REMARKS

Objections and Rejections Pertaining to Form

FIG. 1 — PRIOR ART-
10
ADDED

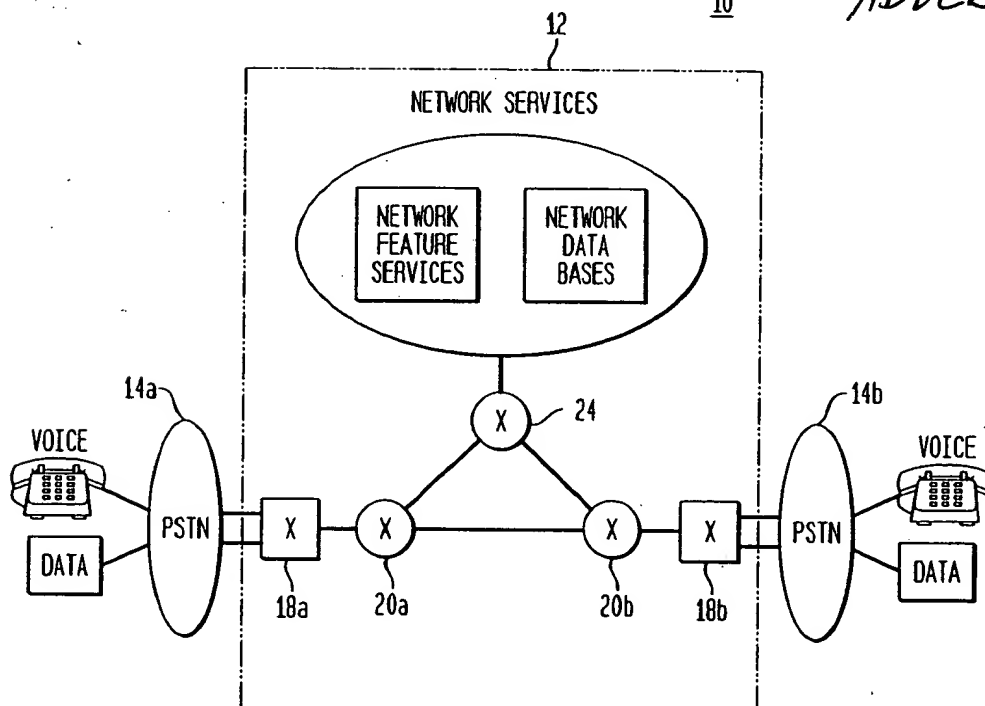
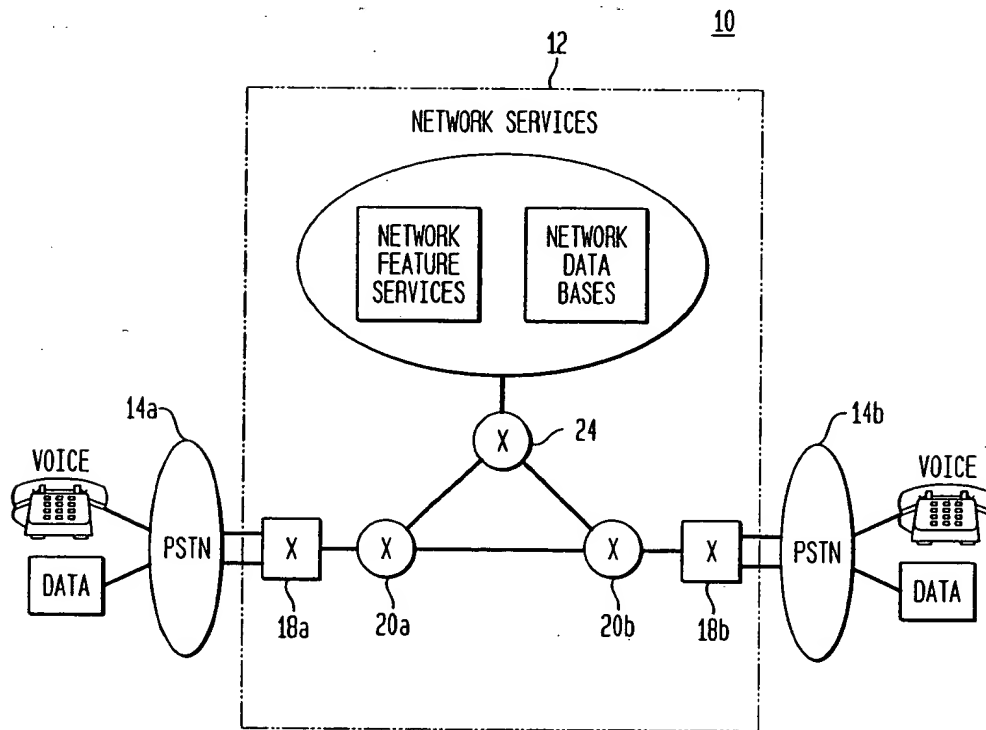
In Section 1 of the Office Action, the Office asserted that Figure 1 should be designated by a legend such as – PRIOR ART --. Applicant has amended Figure 1 accordingly.

FIG. 3A

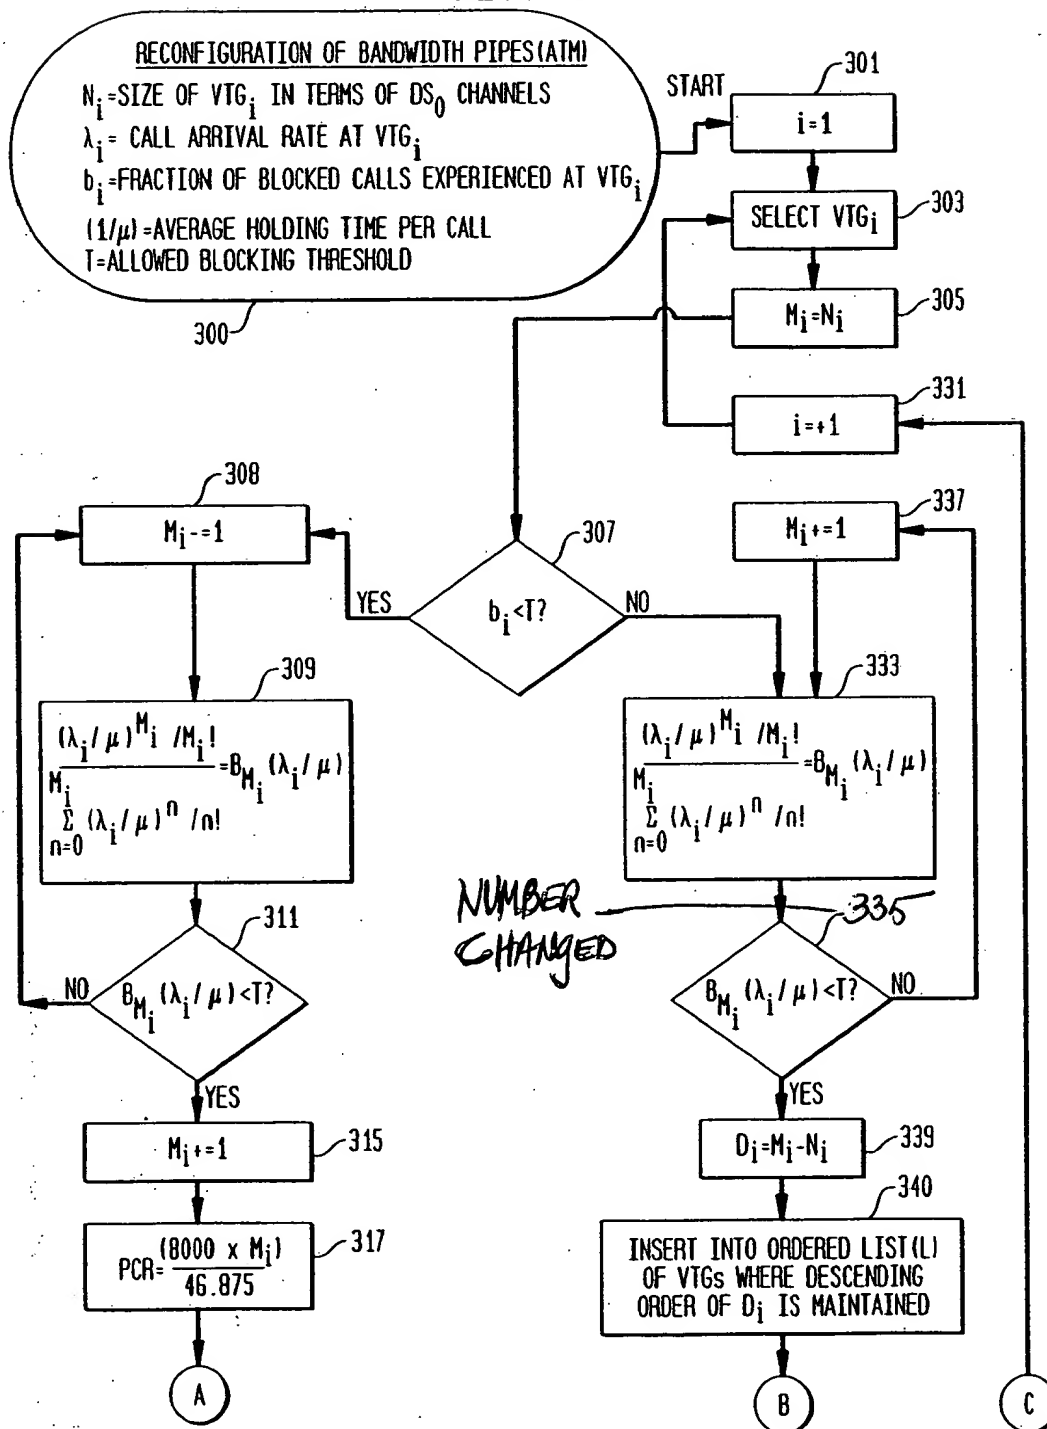
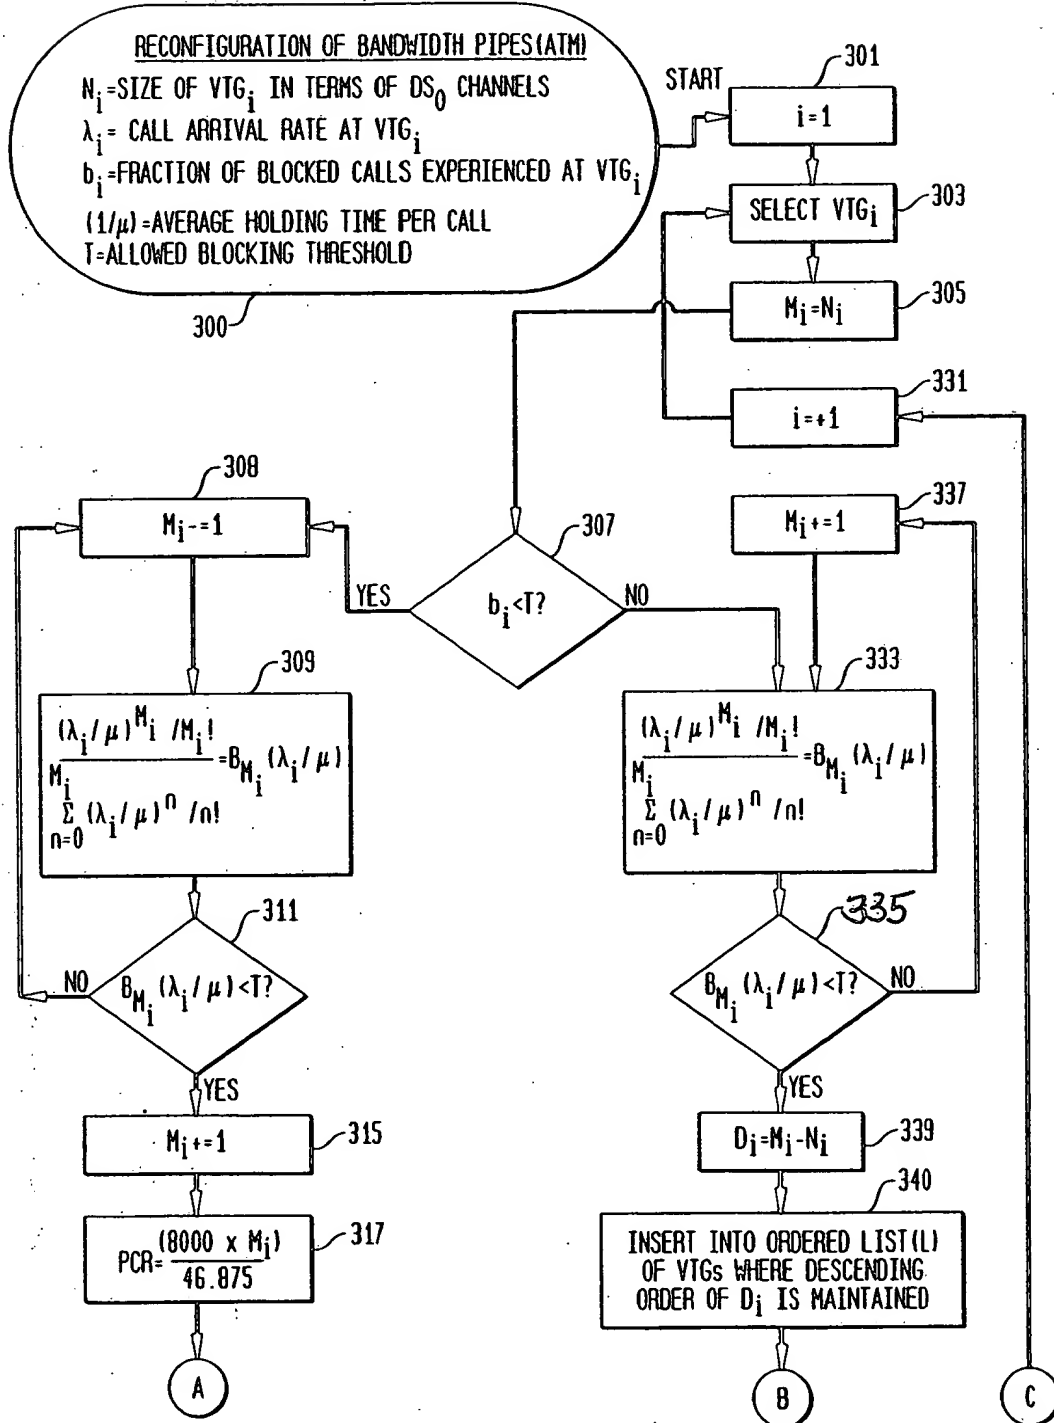
In Section 3 of the Office Action, the Office further objected to the drawings because reference numeral 311 located after reference numeral 333 in Figure 3 should be relabeled as reference numeral 335 in order to match page 25 of the specification; “if” should be “is” in step 641 of Figure 6C; and reference numeral 924 in Figure 9B should be relabeled as reference numeral 935 in order to match page 56 of the specification. Applicant submits herewith proposed drawing corrections in accordance with the Office’s remarks.

In Section 9 of the Office Action, the Office rejected claims 3-5, 12-16, 19-28, 32 and 34-38 under 35 U.S.C. §112, first paragraph, asserting that claims 3, 19 and 34 disclose an equation which includes the term "M!," whereas the specification (page 20, line 12 – page 21, line 13) has the term as "Mi," and even furthermore, Figure 3A shows the term as "Mi!". The Office noted, however, that it will interpret the term to be "Mi!"

Applicant has amended the specification and claims 3, 19 and 34 to consistently use the term "Mi!" Once again, as a peripheral matter, this appears to be a rejection under 35 U.S.C. §112, second paragraph, not first paragraph. Particularly, the Office does not appear to question that it is apparent from the application that "M1!" is the intended term. It is just that there are one or more typographical errors in the application.
